RENESAS TECHNICAL UPDATE

Product Category	MPU & MCU	Document No.	TN-16C-A213A/E	Rev.	1.00
Title	Errata to R32C/118A Group User's Manual: Hardware	Information Category	Technical Notification		
Applicable Product	R32C/118A Group	Lot No.	Reference Document	R32C/118A Group User's Manual: Hardware Rev. 1.00 (REJ09B0577-0100)

This document describes corrections to the R32C/118A Group User's Manual: Hardware, Rev. 1.00. The corrections are indicated in red in the list below.

Figure 8.1 Clock Generation Circuitry

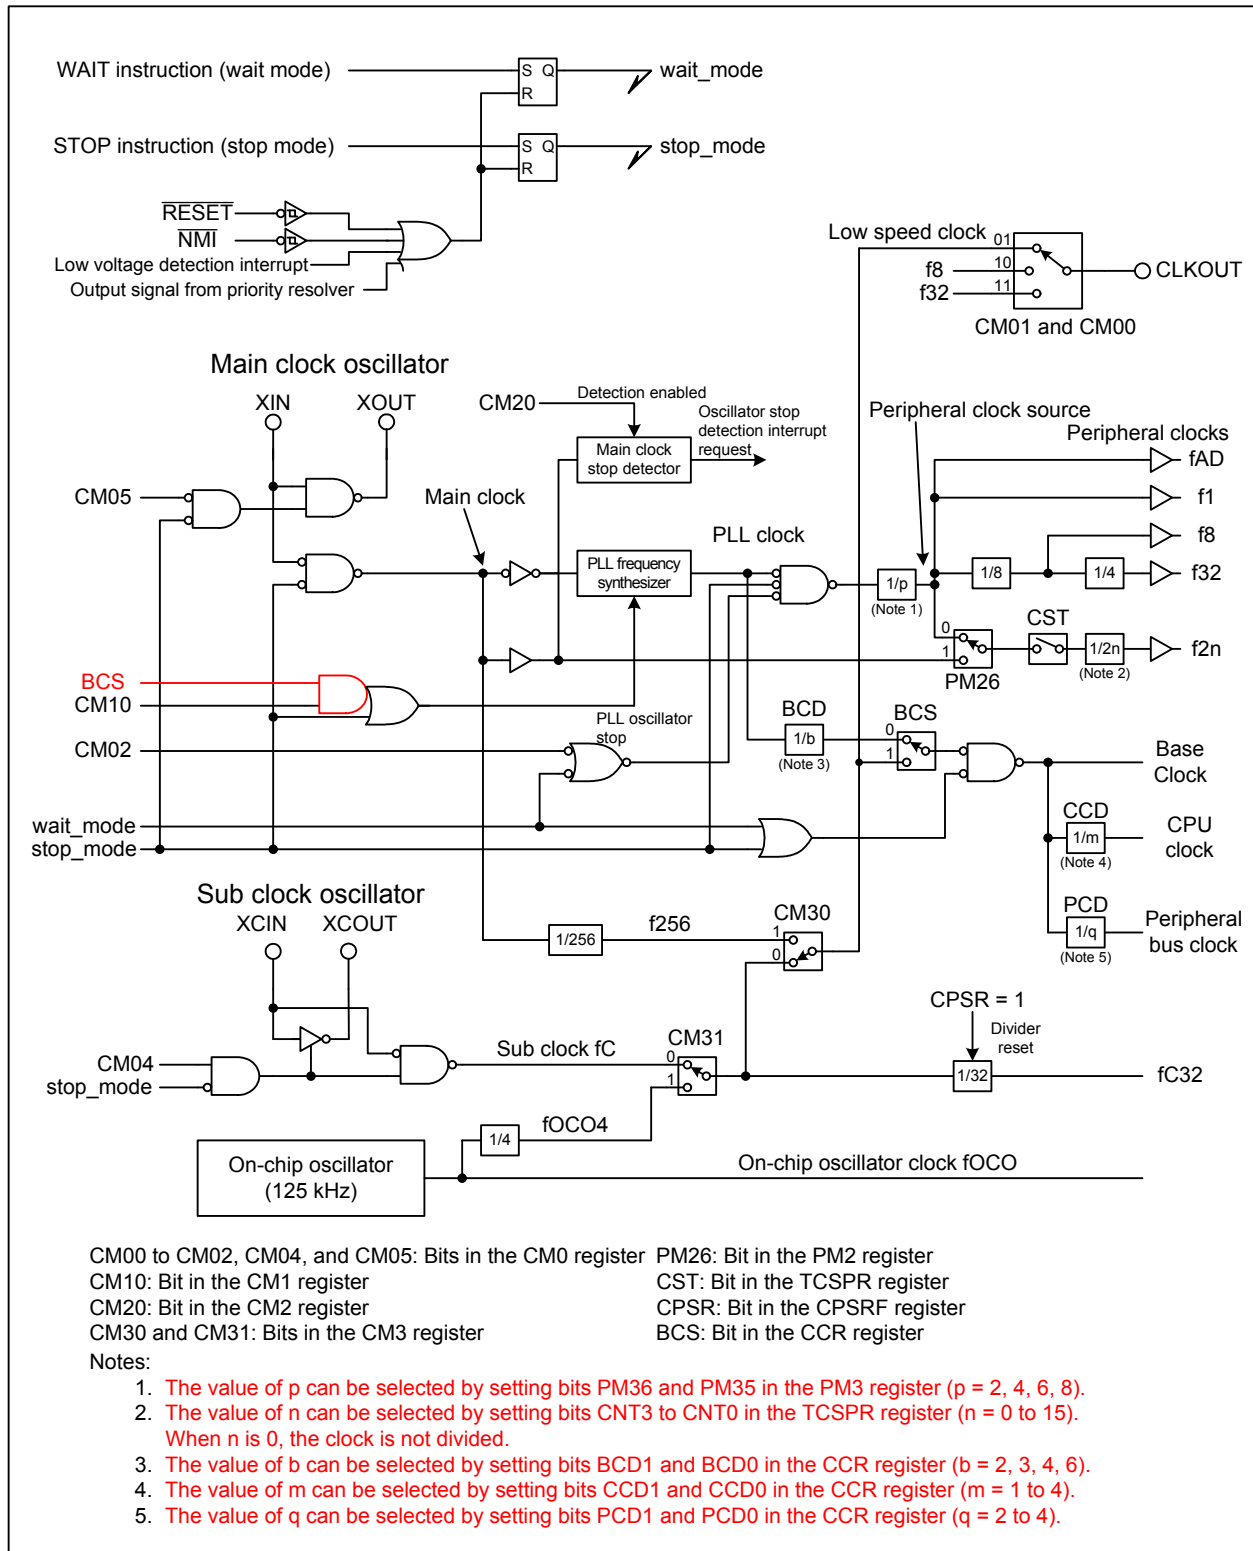
•Page 100 of 639, Figure 8.1 is corrected as follows:

Figure 21.1 CRC Calculator Block Diagram

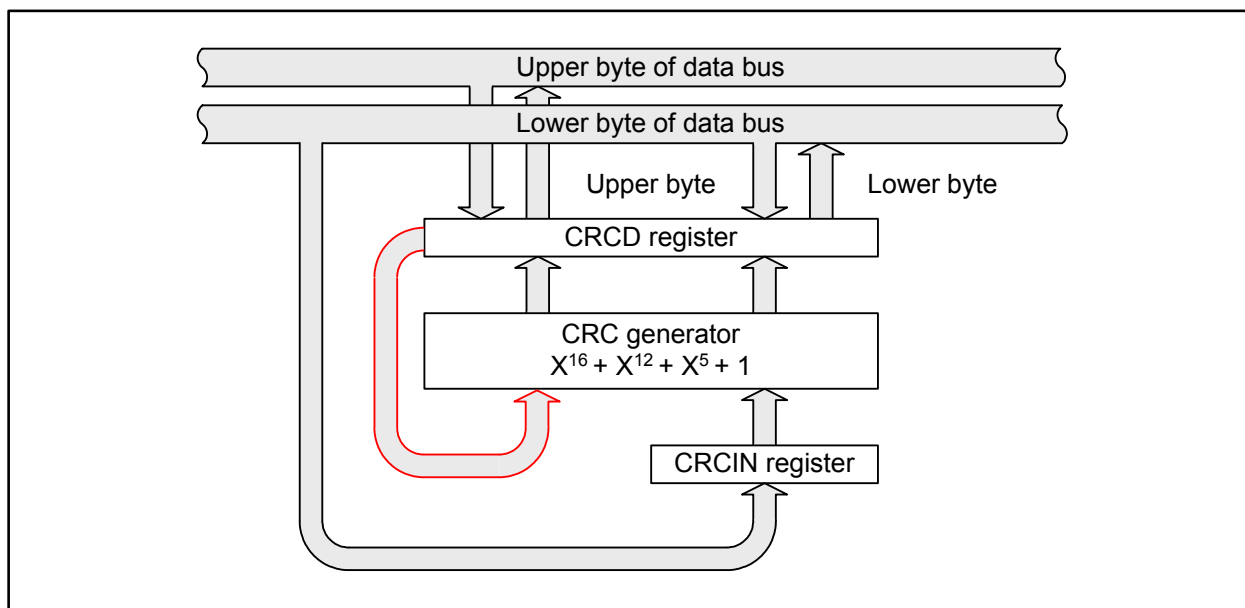
- Page 333 of 639, description in 19.1.5 is modified as follows:
 “In repeat sweep mode 1, the analog voltage applied to eight selected pins including **one to four** prioritized pins is repeatedly converted into a digital code. Table 19.6 lists specifications of repeat sweep mode 1.”
- Page 333 of 639, description for the function in Table 19.6 is modified as follows:
 “**The analog voltage applied to eight selected pins including one to four prioritized pins is repeatedly converted into a digital code. The prioritized pins are selected by setting bits SCAN1 and SCAN0 in the AD0CON1 register and bits APS1 and APS0 in the AD0CON2 register**”
- Page 342 of 639, description “AD0i register” in the ninth bullet point of 19.3.2 is modified as follows:
 “**AD00 register**”
- Page 345 of 639, Figure 21.1 is corrected as follows:

Figure 27.1 Typical I/O Pin Block Diagram (i = 0 to 19; j = 0 to 7)

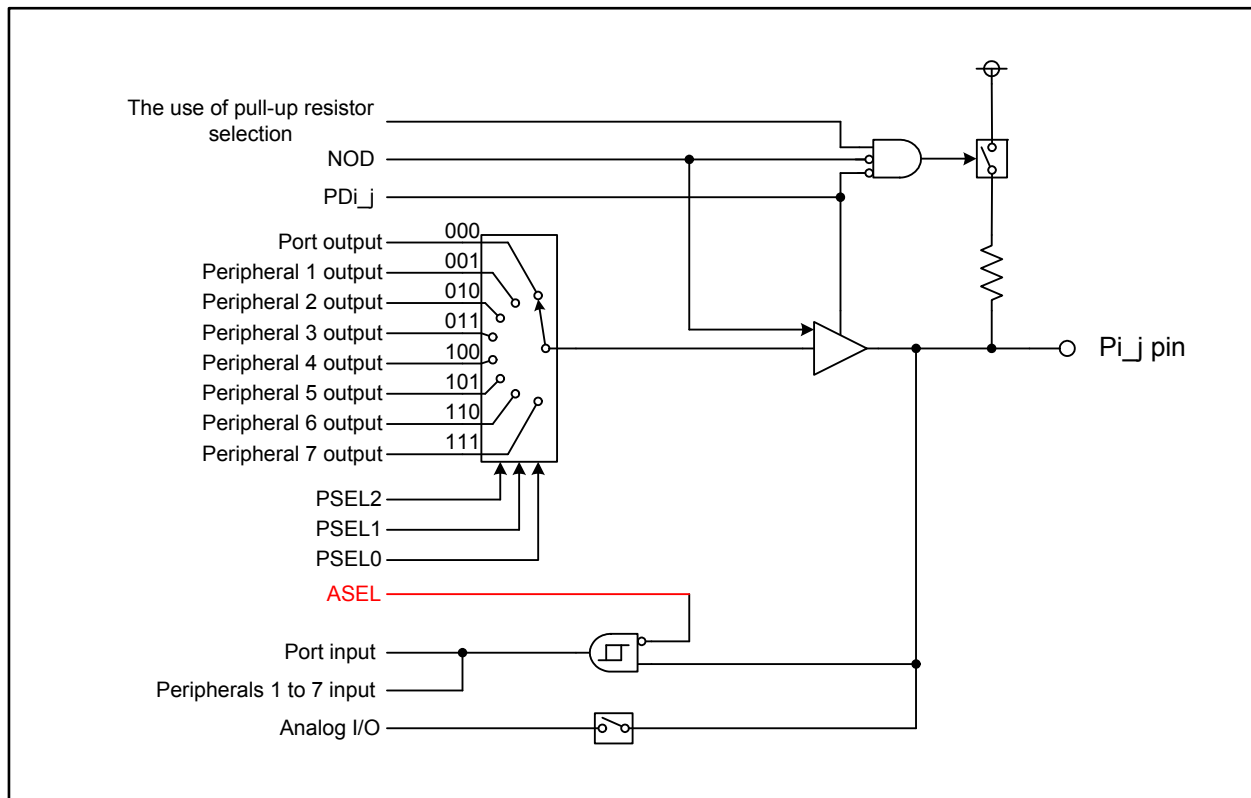
- Page 501 of 639, Figure 27.1 is corrected as follows (refer to TN-16C-A200A/E):
